**Statement of Response to DLR LRD Opinion
Reg Ref.: LRD2/002/24**

Proposed Large-scale Residential Development

Vector Motors, Goatstown Road, Dublin 14, D14FD23

Applicant:	Orchid Residential Ltd
Project Title:	Vector Motors, Goatstown Road, Dublin 14, D14FD23
Document Title:	Statement of Response to DLRs LRD Opinion
Document No:	Final

Figure 2 - SHD Application ABP 313235_22 - Fifth Floor Level

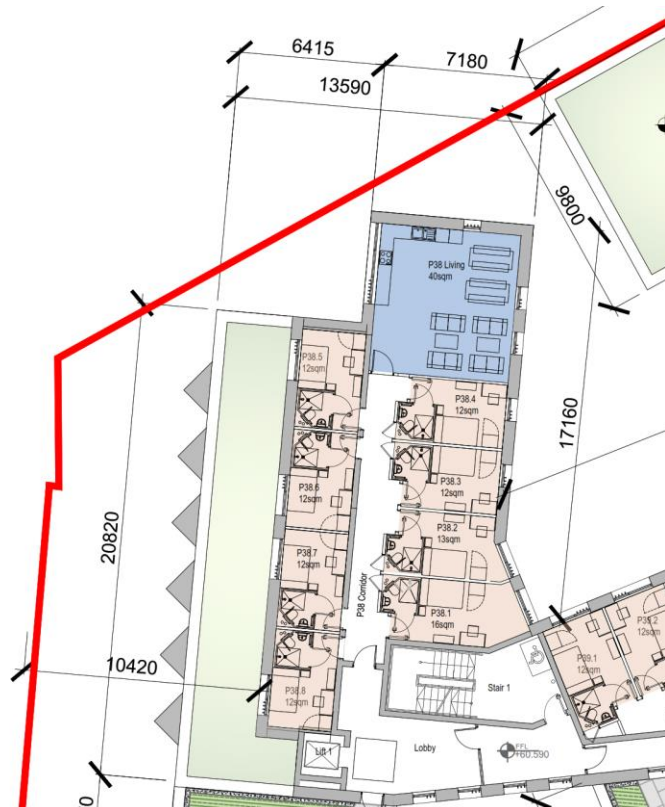
2. Prior to the commencement of development, the applicant shall submit revised drawings for the written agreement of the planning authority, complying with the following requirements:

Response: Cluster 38 was removed from the fifth-floor level and the remaining cluster was reconfigured to provide for an increased setback from the northern boundary. The revised fifth floor plan includes an additional setback to the northern boundary resulting in a 10m setback from the site boundary as required above. This results in an 18m setback from the adjoining Trimbleston building. The roof space adjoining the newly configured cluster to the north is a green roof and not accessible to residents. The drawing extracts below provide a comparison between the scheme discussed at the LRD Opinion meeting and the revise proposal as submitted. The images illustrate the changes made to the proposal in response to the above.

Figure 5 - Extract - Setback from 10 Willowfield Park

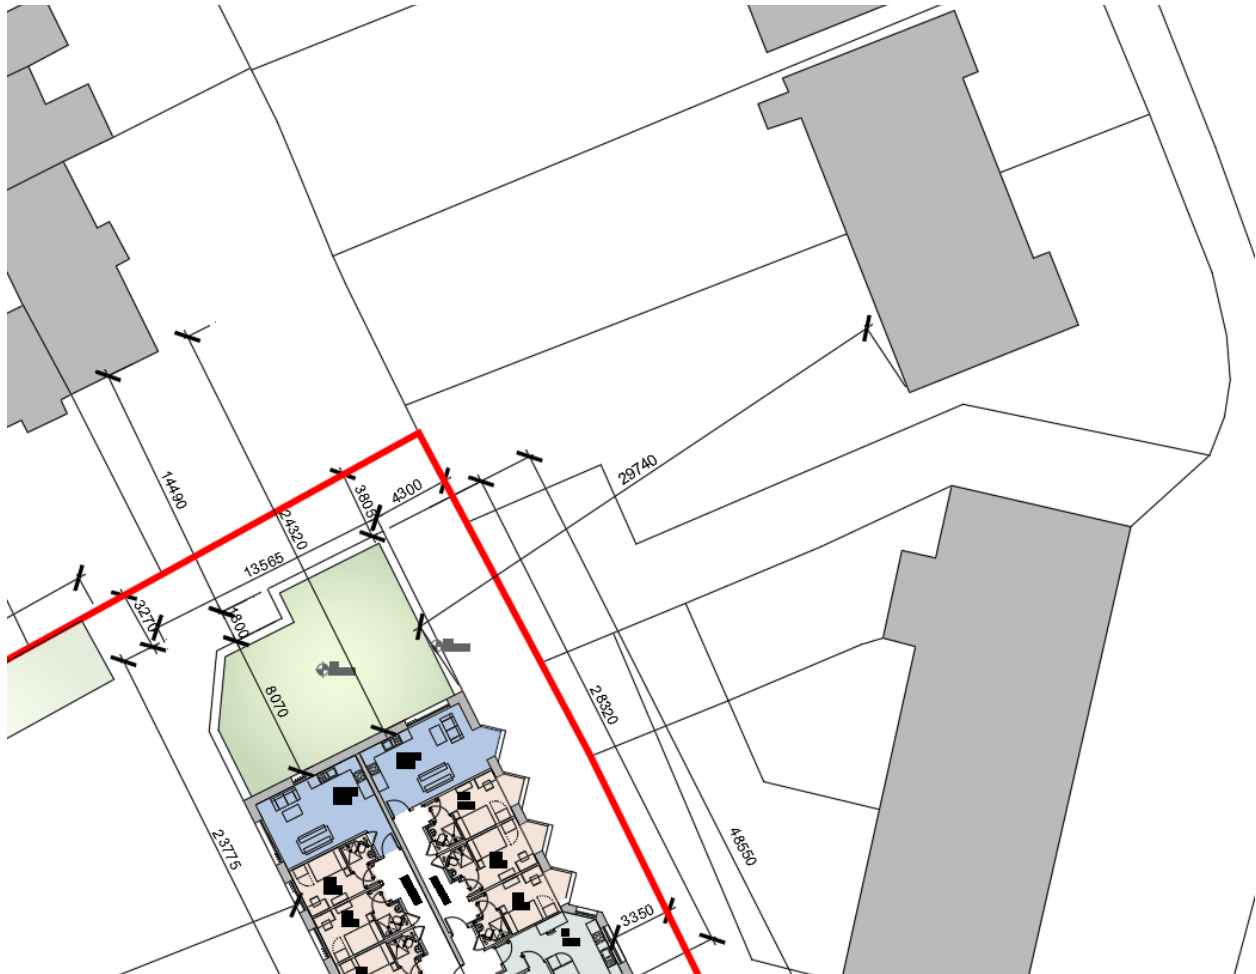
- iv. Views towards the rear garden of No. 10 Willowfield Park from the south facing living room windows on the second and third floors of the block to the rear (southeast) of the site shall be obscured by way of louvers.

Response: The windows are setback more than 30m from the boundaries. The development plan requires a setback from adjacent windows on neighbouring properties only. The proposal complies with the requirements of the development plan including a setback of more than 30m from the nearest window of No. 10 Willowfield Park. The applicant is willing to accept a condition to include louvers if required.

Figure 7 - Extract site layout plan showing the location of bicycle parking on the site

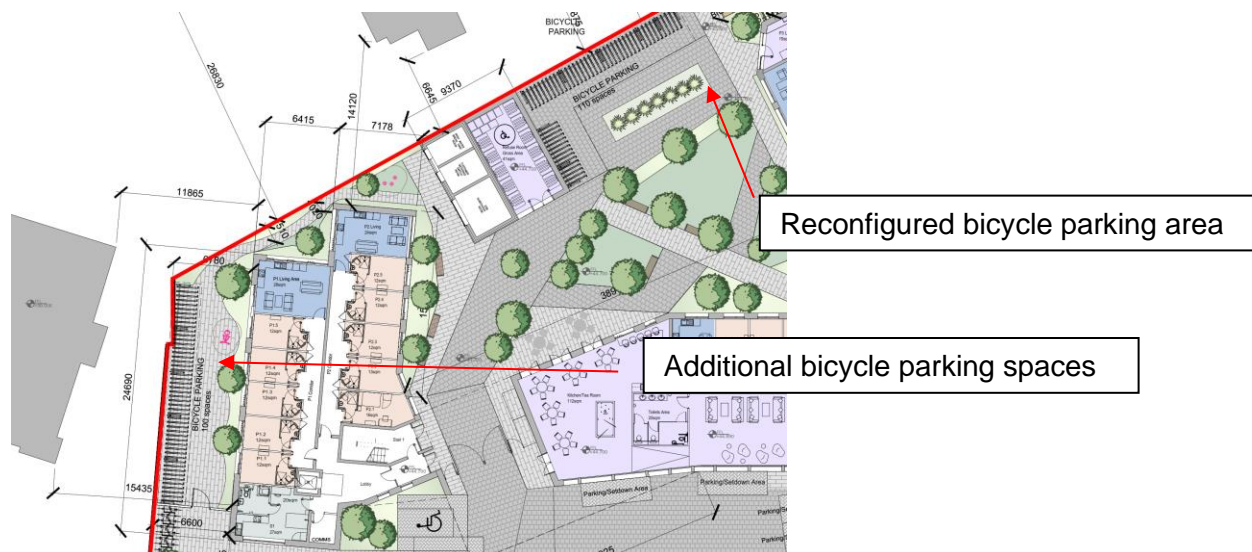
- v. *Clusters P3 & P4 and Studio S2 on the ground floor of the block to the rear (southeast) of the site shall be omitted and the proposed refuse store and long-stay bicycle parking incorporated within the ground floor of this block.*

Response: The bicycle parking area has been redesigned to accommodate additional Sheffield stands for resident long-stay parking adjacent to the northern boundary of the site. A total of 218 no. cycle parking spaces are provided across the site for resident and visitor use.

Figure 21 - Location of Communal Amenity Space throughout the site

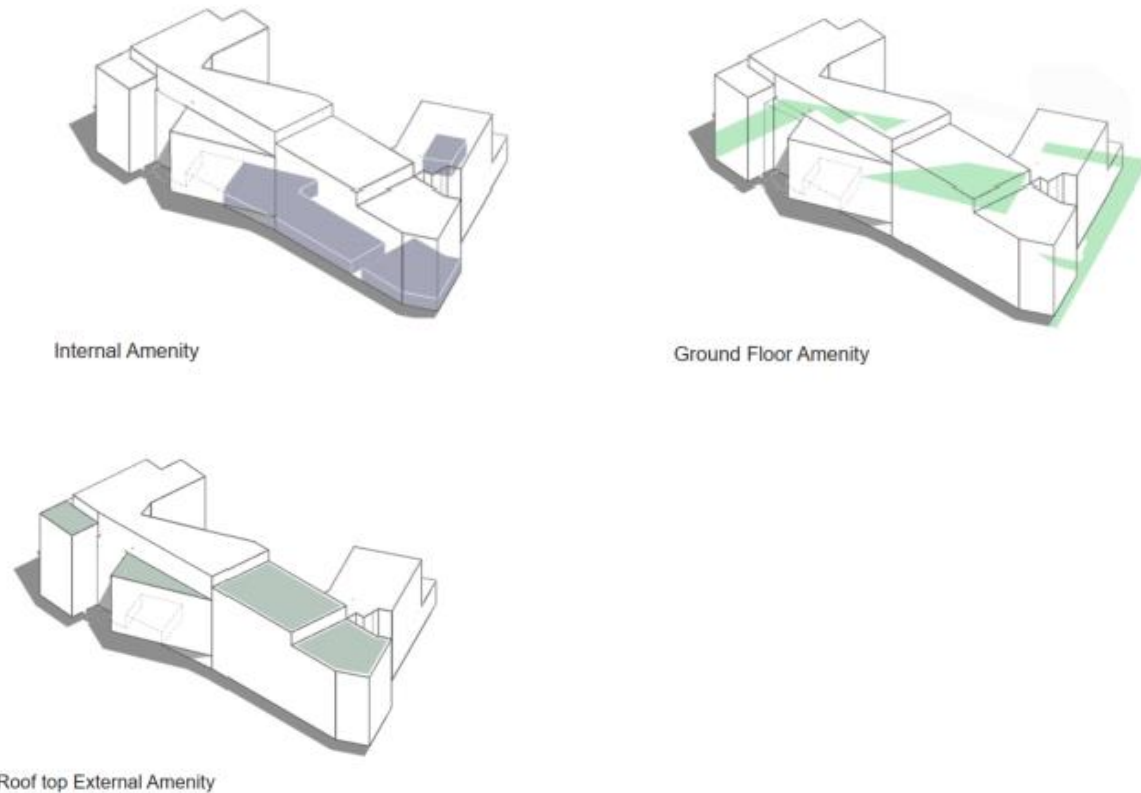
"A quantitative and qualitative assessment which provides a breakdown of the communal and public open space, or otherwise. The assessment shall detail the functionality of the public space and shall disregard any areas required for circulation space such as footpaths between buildings etc.."

In response to Item 7, we refer the Planning Authority to the submitted Urban Design Statement by RAU which illustrates the breakdown of the communal open space areas throughout the site.

Amenity space is provided in a variety of internal and external forms for both passive and active use. External amenity space within the development amounts to 1,247 sqm. This is comprised of a large central courtyard within the development, a smaller courtyard space adjacent to Student Lounge 2 and four roof garden spaces all adjacent to Goatstown Road. These spaces provide green space within the development for a communal meeting point and restful space.
